ADDENDUM NO. 3

March 4, 2011
09076.D

to the construction documents
Beacon Hill Linear Park Phase One
CIMS Project No. 2600572

4 L2.3 ADD ALTERNATE NO.2

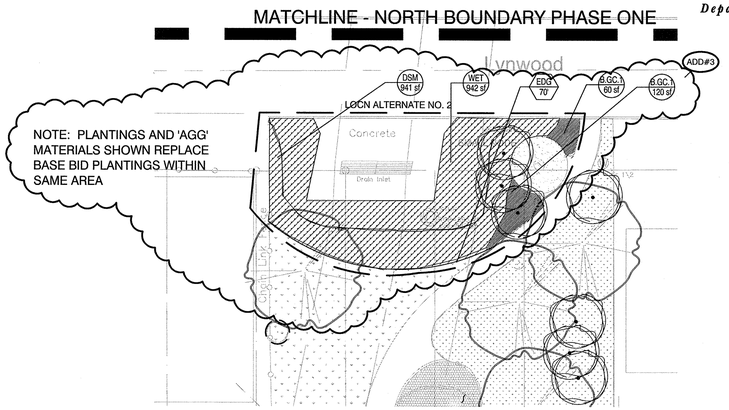
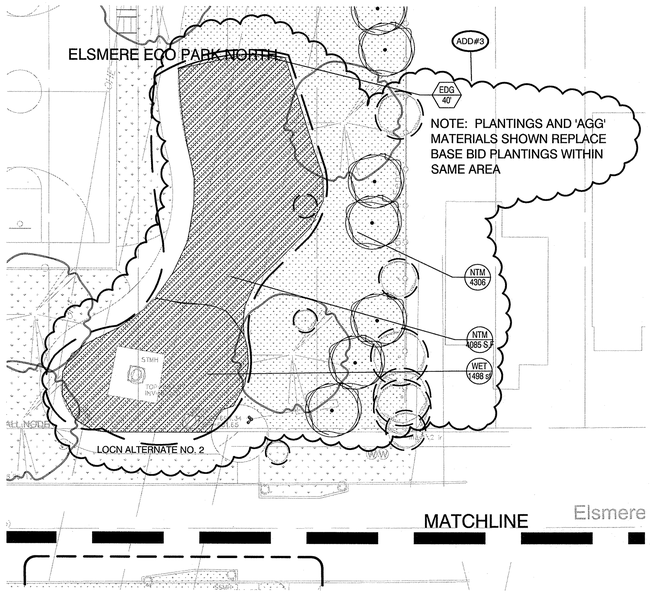
DETAIL REMOVED ADD#3

C3.0

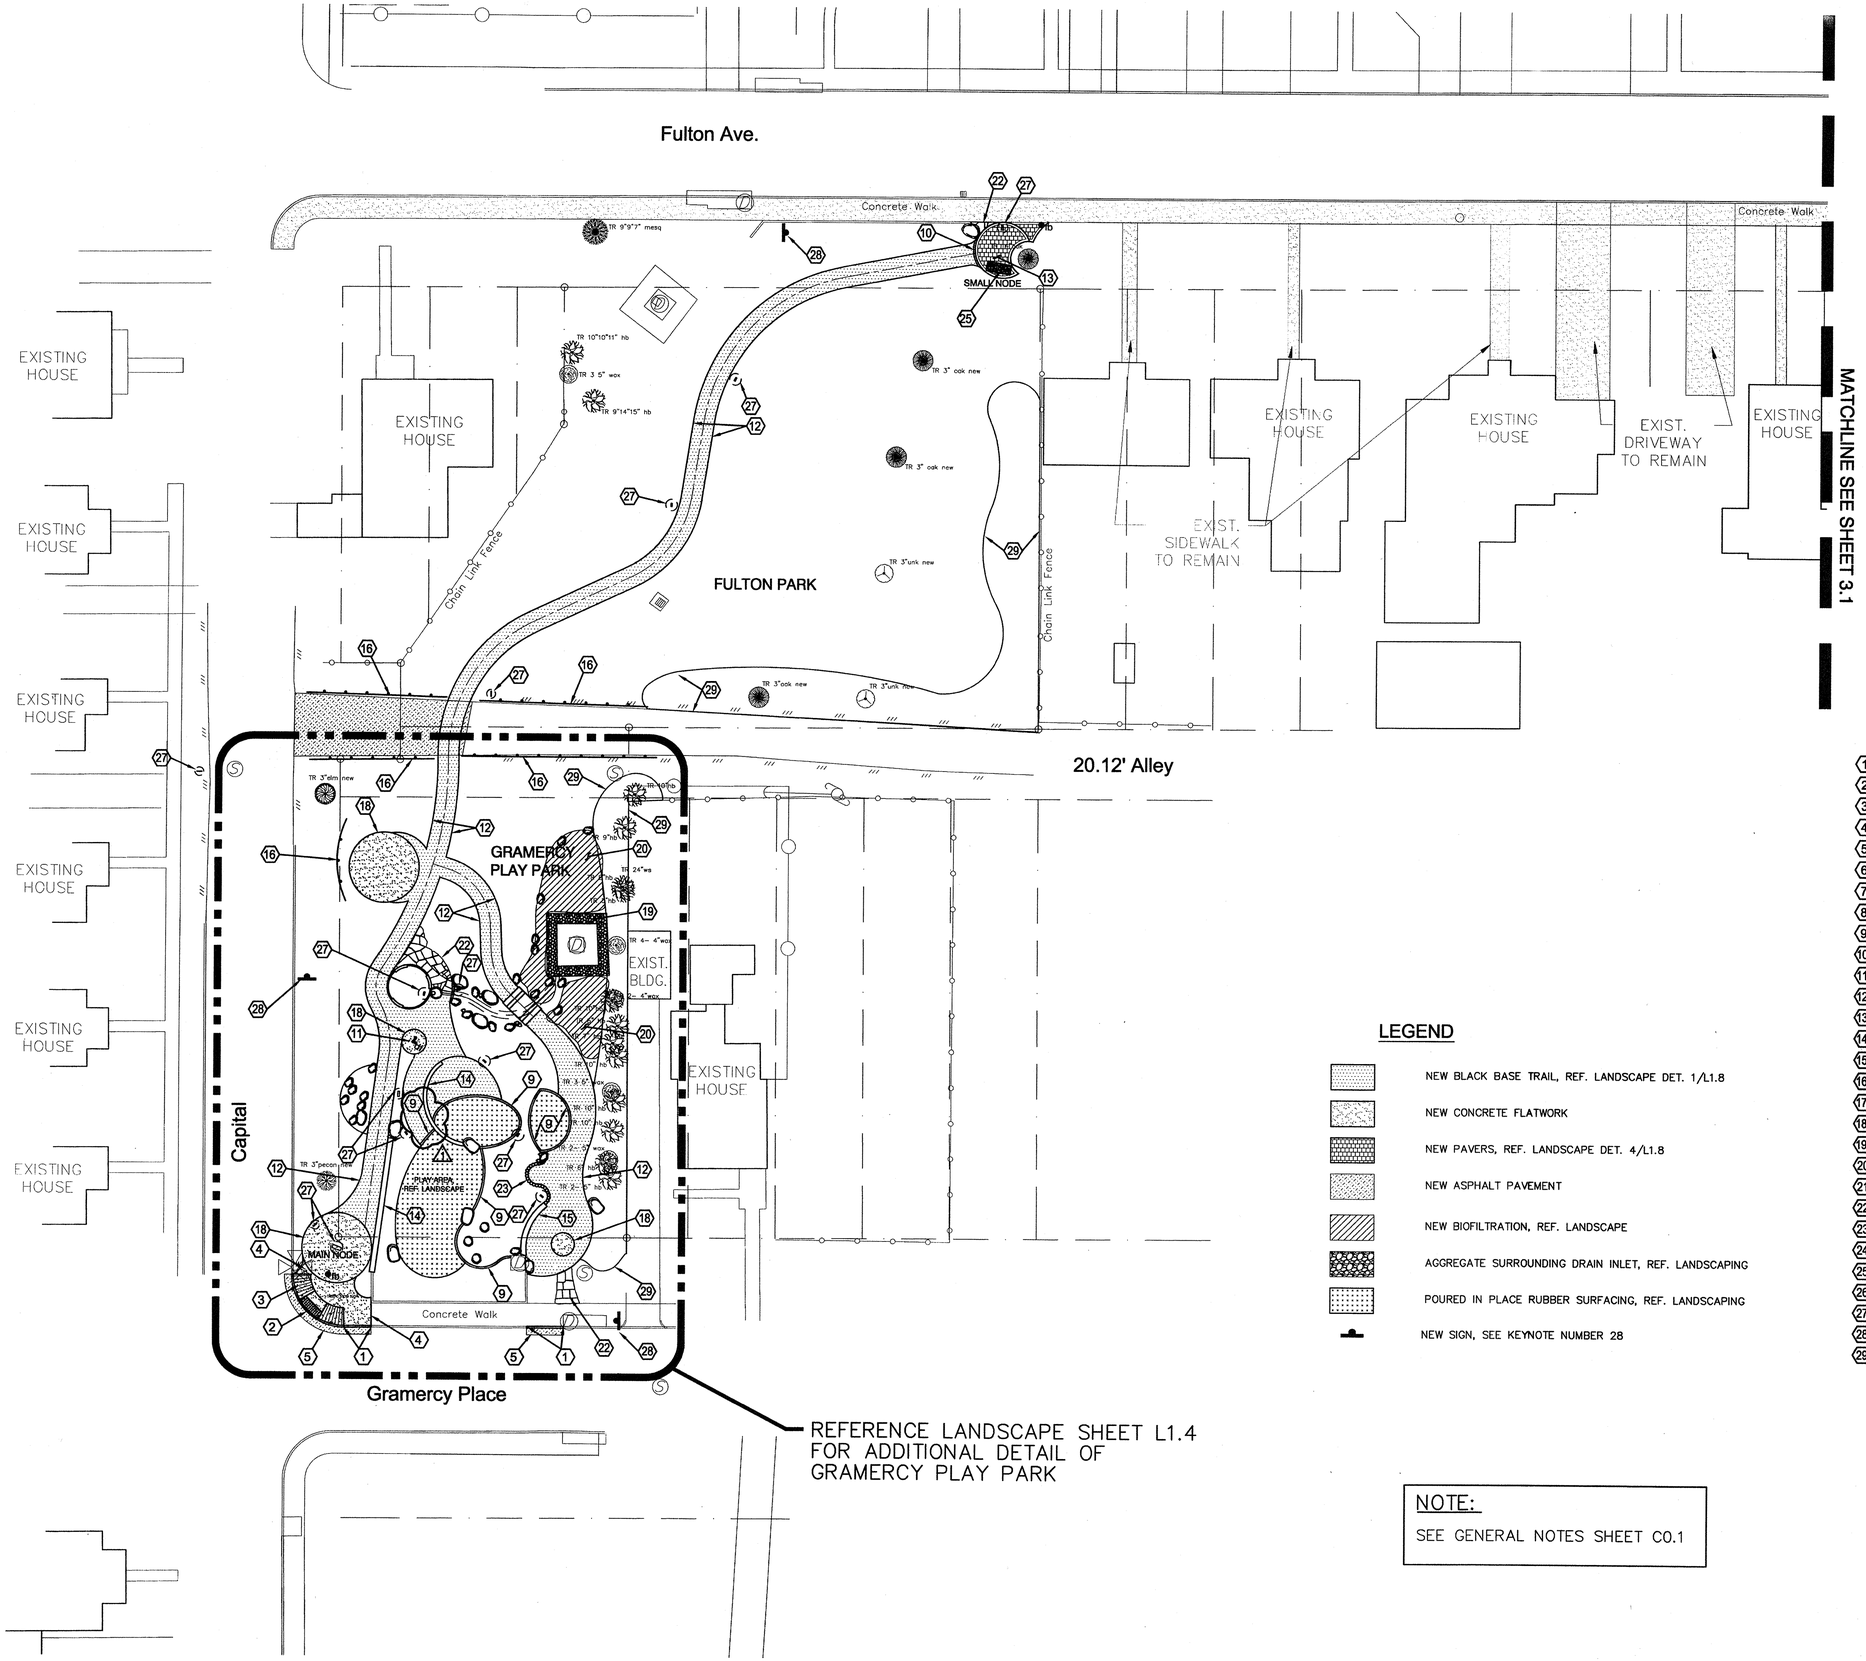
3.02 ***Question:*** *Alt. #4 on sheet L1.20 shows concrete slab and an asphalt apron tying into the trail. On sheet C3.0A shows concrete for the apron. Which will it be?*
Answer: Asphalt apron tying into the trail.

3.03 **Question:** *Alt. #3 on sheet shows replace existing sidewalk with new sidewalk in asphalt. On sheet C3.0A shows concrete for the new sidewalk. Please clarify which will be used.*
Answer: Use concrete for the new sidewalk.

REVISION:
ADDED PLAY AREA CURB

C3.1

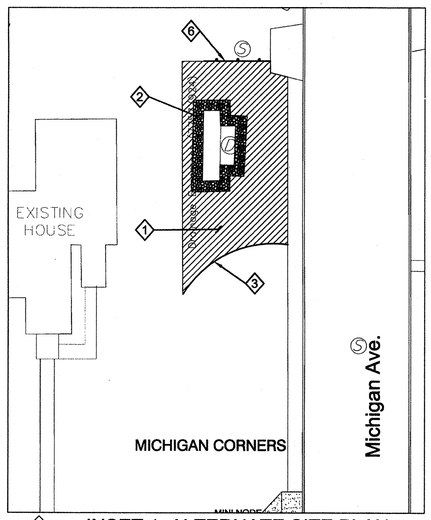
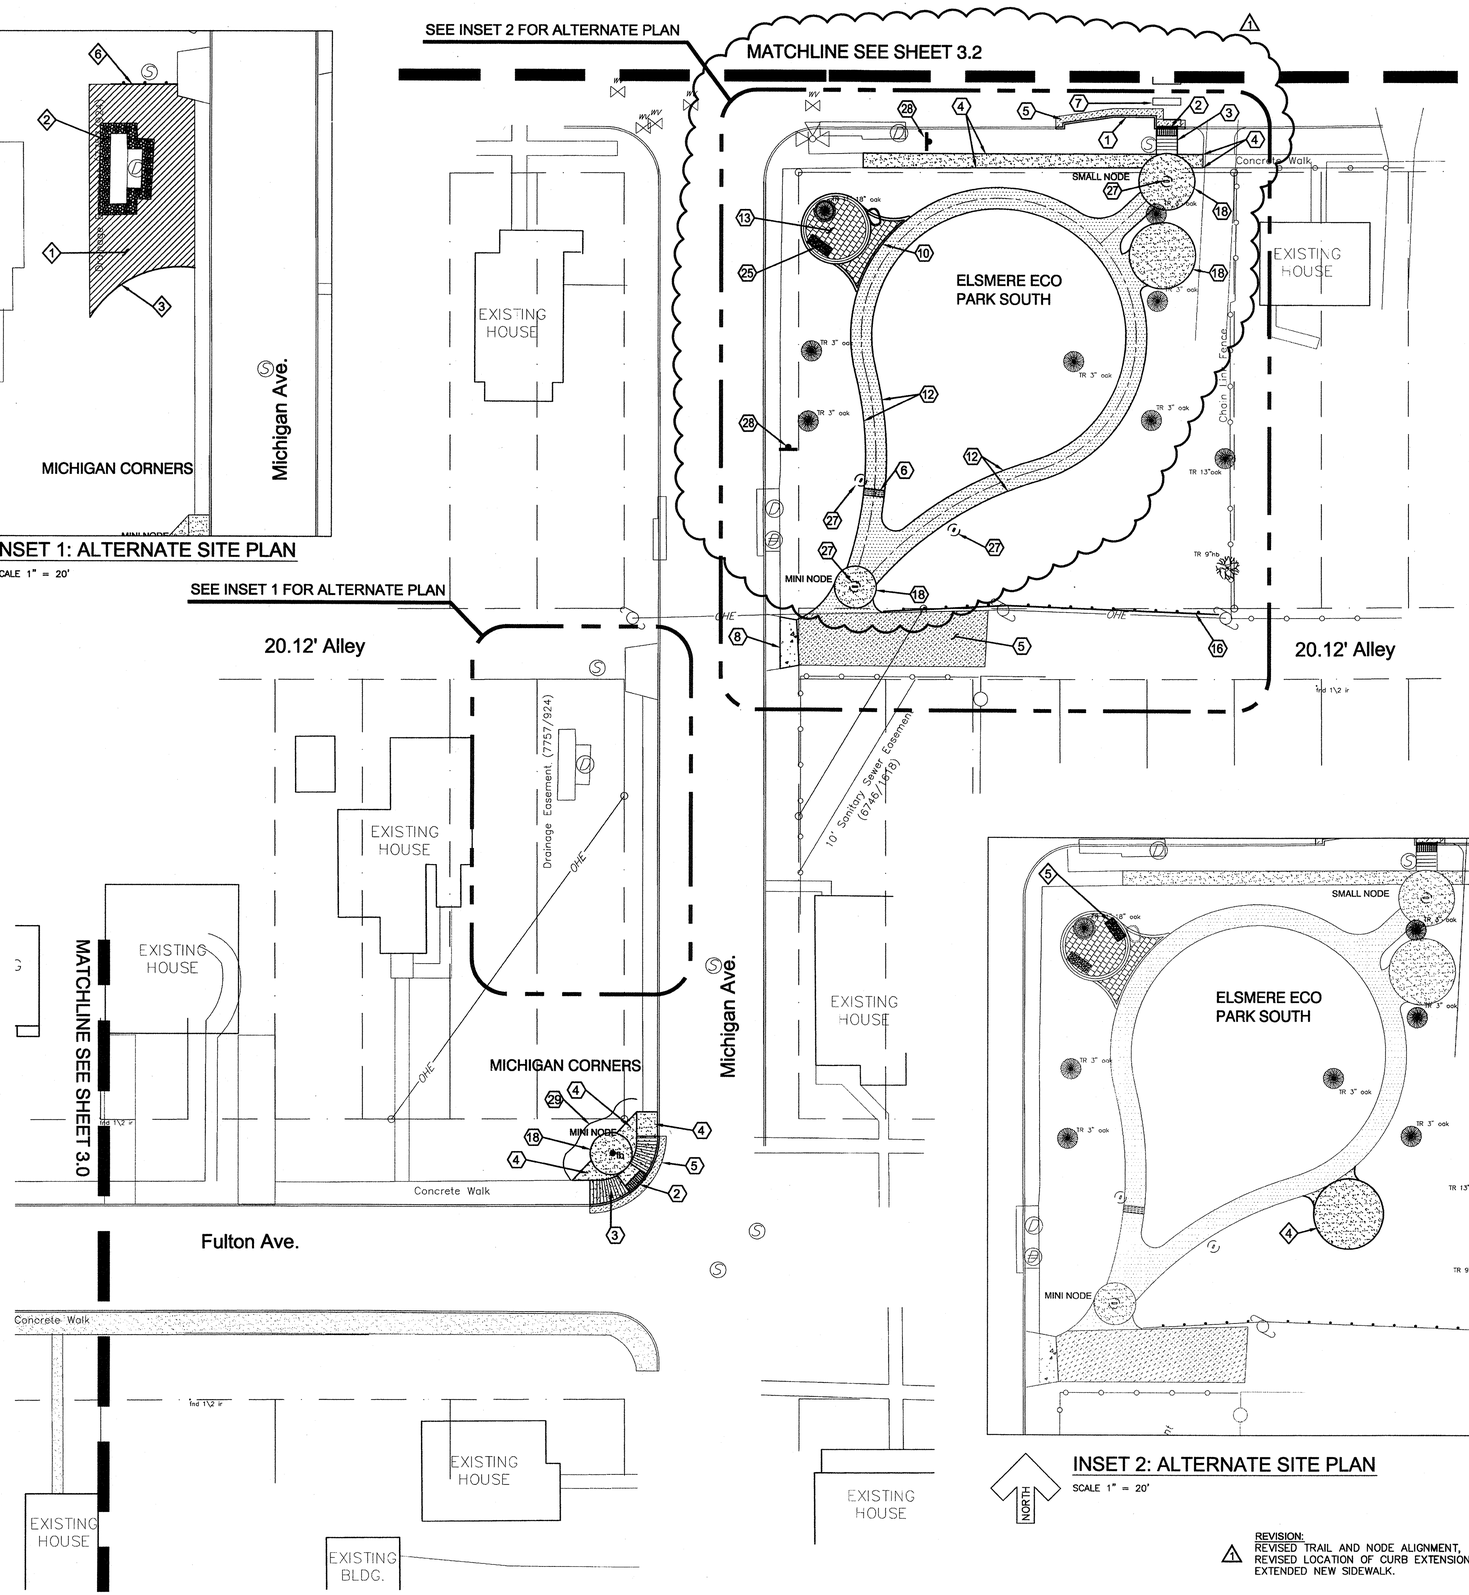
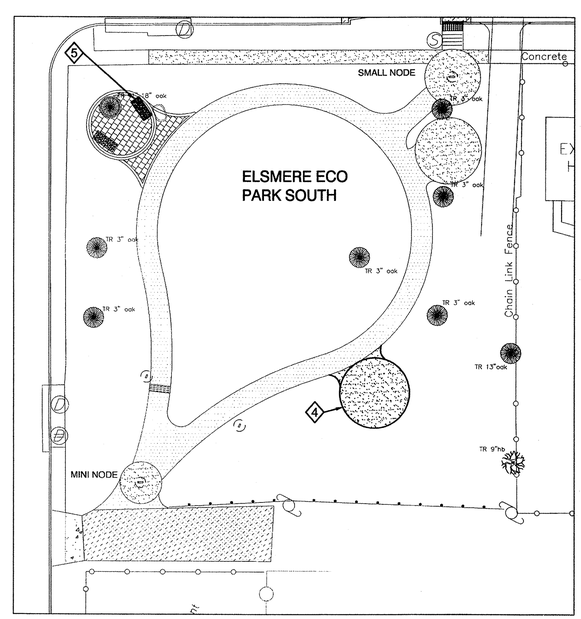
3.01 ***Question:*** *Sheet C3.1 shows an alternate for Elsmere Eco Park South. The Alternates listed in the specifications do not show anything for this location*
Answer: INSET 2: ALTERNATE SITE PLAN indicates one (1) future Bench and one (1) future Picnic Unit; both are listed within the Unit Pricing Form.

3.04 ***Question:*** *Alt. #2 showing planting on L1.21. But on sheet C3.1 detail top left corner shows some post and cable as well but is not listed on the Alt. Will this item be added to Alt. #2?*
Answer: The post and cable barrier is to be included in the base bid only as shown on 1/L.2 – HARDSCAPE PLAN.

REVISION:
REVISED TRAIL AND NODE ALIGNMENT,
REVISED LOCATION OF CURB EXTENSIONS,
EXTENDED NEW SIDEWALK.

C3.2

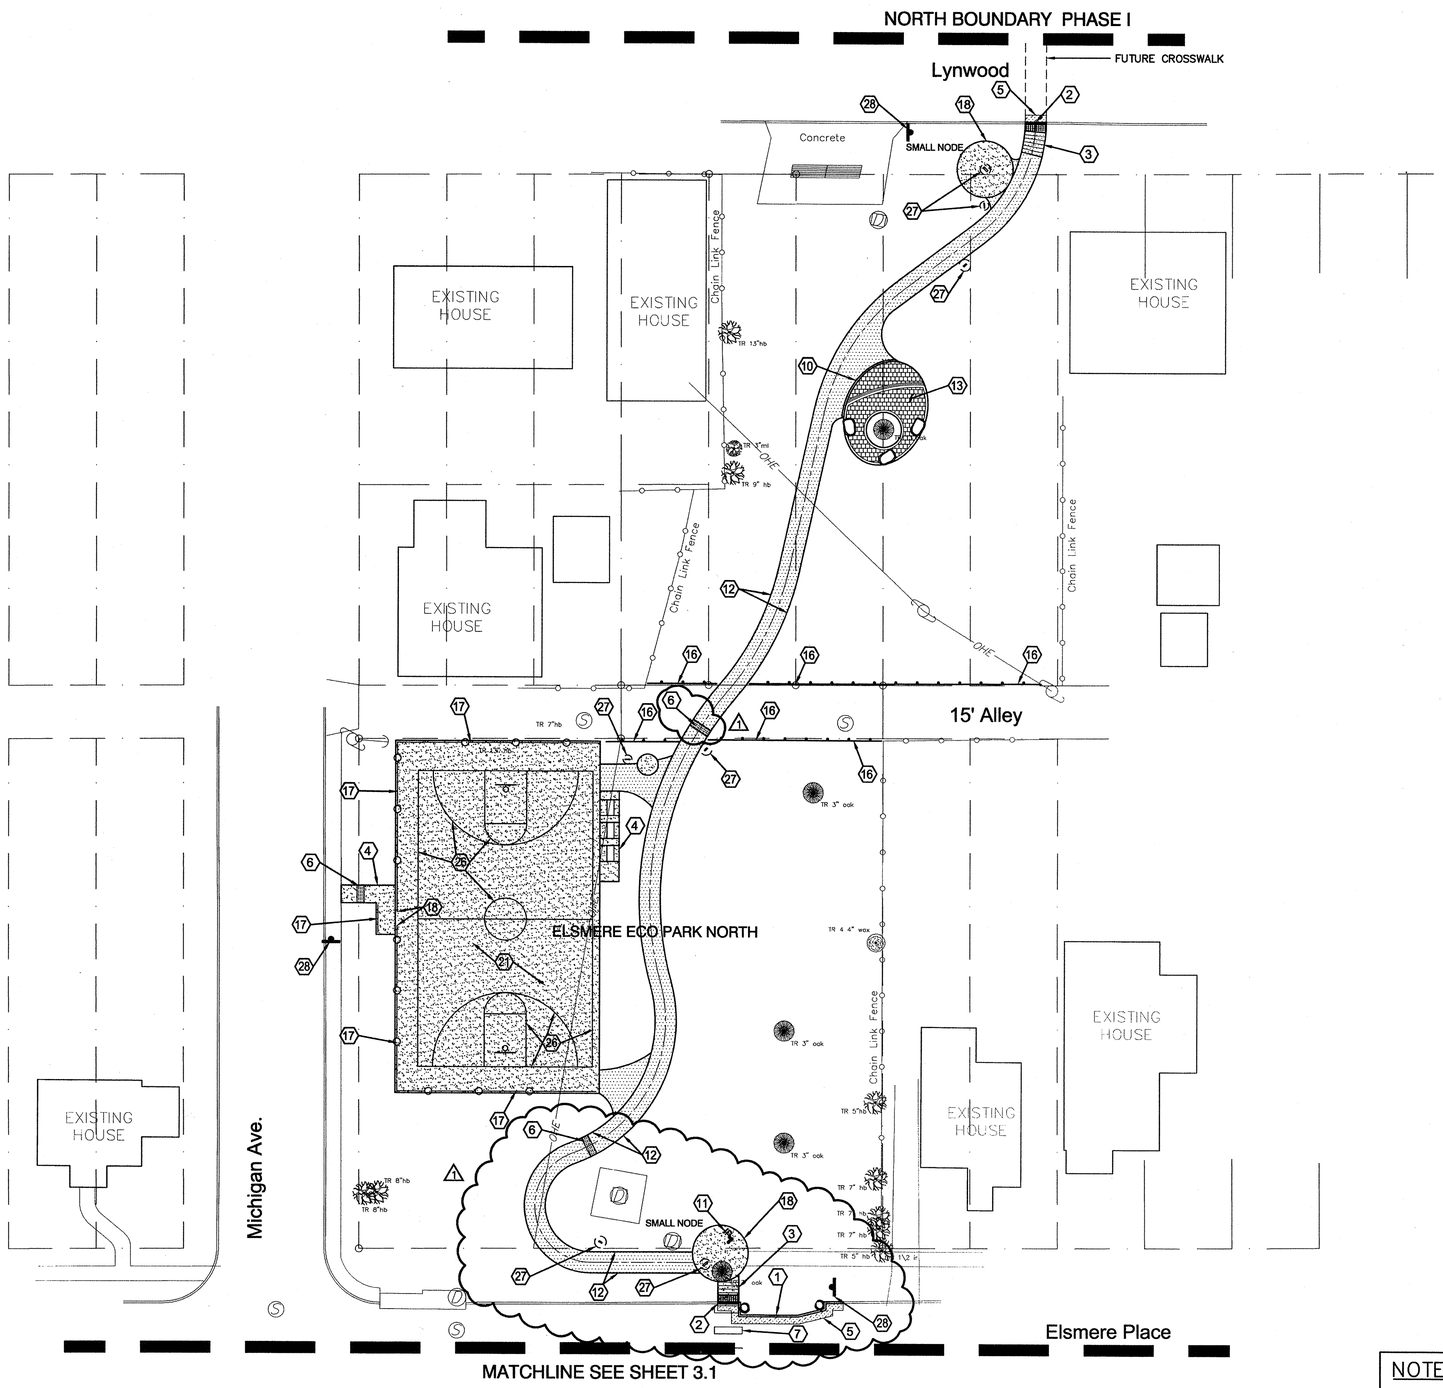
REVISION:
REVISED TRAIL AND NODE ALIGNMENT, ADDED SIDEWALK DRAINS.
